South Texas Project Electric Generating Station P.O. Box 289 Wadsworth, Texas 77483

September 26, 2019  
NOC-AE-19003677  
10 CFR 50.90

South Texas Project  
Units 1 & 2

License Amendment Request to Revise Technical Specifications to Adopt TSTF-490, Revision 0,  
"Deletion of E Bar Definition and Revision to RCS Specific Activity Tech Spec."

FIGURE 3.4-1

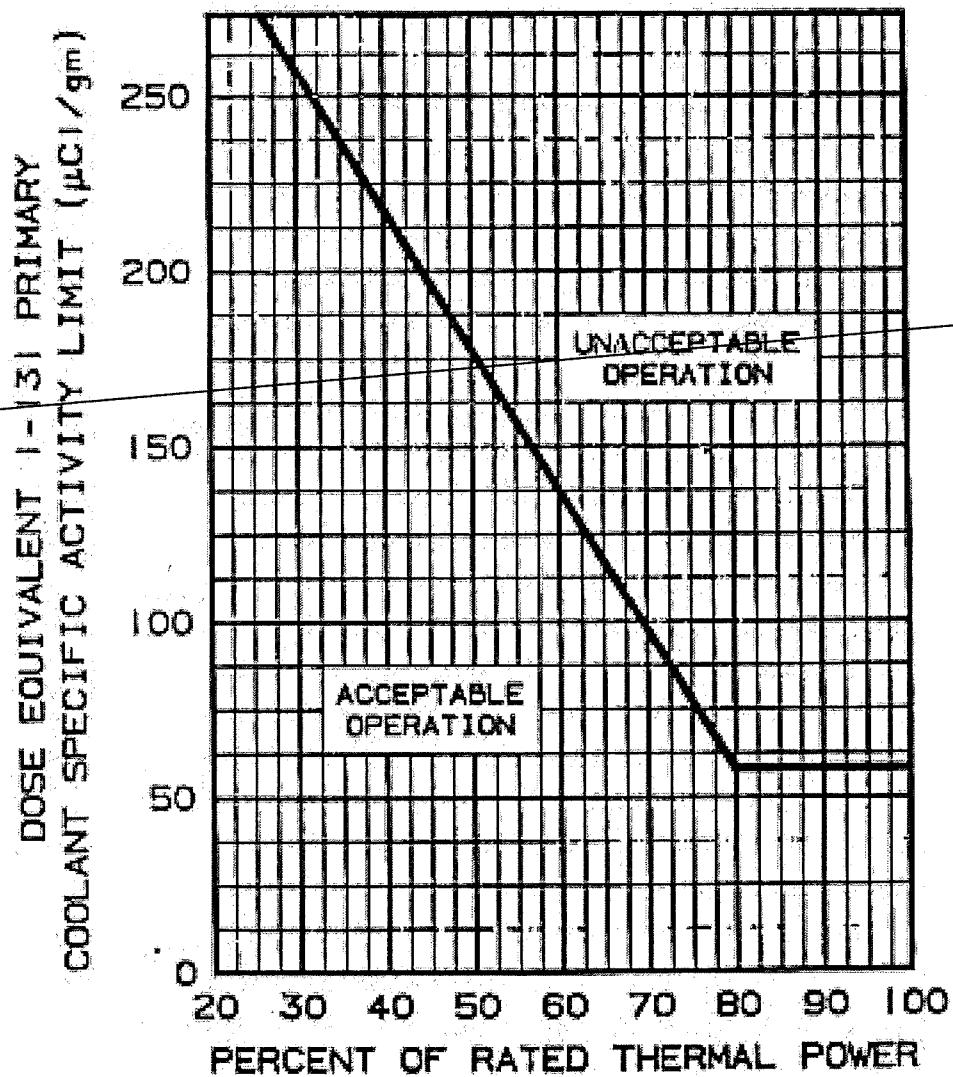
1. Delete the definition of  $\bar{E}$ - AVERAGE DISINTEGRATION ENERGY.
2. Add a new Technical Specification definition for DOSE EQUIVALENT XE-133.
3. Revise LCO 3.4.8 "SPECIFIC ACTIVITY" to read as follows: "Reactor coolant system DOSE EQUIVALENT I-131 and DOSE EQUIVALENT XE-133 specific activity shall be within limits." and delete Figure 3.4-1. The removed limit values are incorporated into the new Action 'a.'

~~4.4.8 The specific activity of the reactor coolant shall be determined to be within the limits by performance of the sampling and analysis program of Table 4.4-4.~~

**4.4.8.1 Verify Reactor Coolant System DOSE EQUIVALENT XE-133 specific activity  $\leq 540$  microCuries per gram at a frequency in accordance with the surveillance frequency control program.**

**4.4.8.2 Verify Reactor Coolant System DOSE EQUIVALENT I-131 specific activity  $\leq 1.0$  microCuries per gram:**

- a. At a frequency in accordance with the surveillance frequency control program, and**
- b. Between 2 and 6 hours after THERMAL POWER change of 15 % or greater RATED THERMAL POWER within a 1 hour period.**
